Service Bulletin

SUBJECT: Service Update for Inventory and Customer Vehicles
Starter Motor Damage Due to Positive Battery Cable and Starter Solenoid
Terminal Contact
Expires with Base Warranty

MODELS: 2013 Chevrolet Sonic
U.S. Vehicles Only

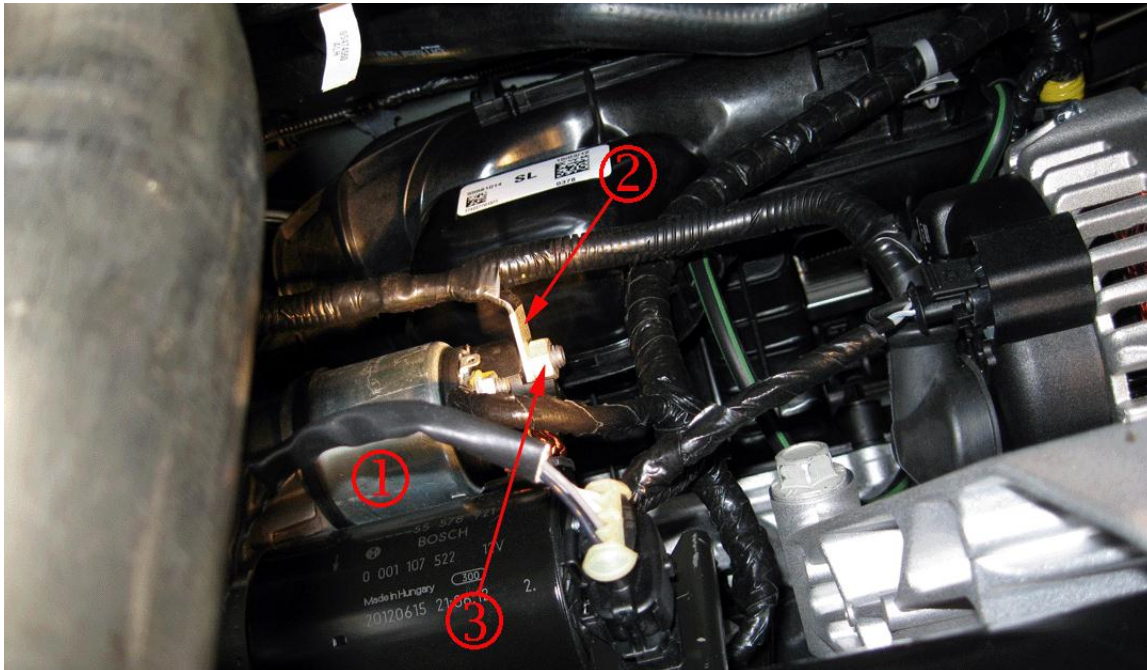
This bulletin provides a service procedure to provide adequate clearance between the battery cable B+ terminal and the starter solenoid on **certain** 2013 model year Chevrolet Sonic vehicles, equipped with turbo engine (RPO LUV). These vehicles may have been produced with potential inadequate design clearance between the battery cable B+ terminal and the starter solenoid. If contact is made between the battery feed and the starter solenoid terminal, the starter motor circuit will be energized and the starter motor will begin to spin. However, the solenoid terminal for the drive pinion gear is not powered therefore, the pinion will not engage the flywheel ring gear and the engine will not be cranking. Within approximately 1 minute excessive heat will begin to melt certain internal starter motor components, the armature will freeze in position and the brush wires will fracture. When this occurs the motor is removed from the electrical circuit. This condition will be accompanied by smoke and odor.

3. Locate the starter solenoid (1), positive battery cable terminal (2) and positive battery cable fastener (3).

1. Disconnect the negative battery cable. Refer to *Battery Negative Cable Disconnection and Connection* in SI.
2. Raise and support the vehicle. Refer to *Lifting and Jacking the Vehicle* in SI.

8. Lower the vehicle. Refer to *Lifting and Jacking the Vehicle* in SI.
9. Connect the negative battery cable. Refer to *Battery Negative Cable Disconnection and Connection* in SI.
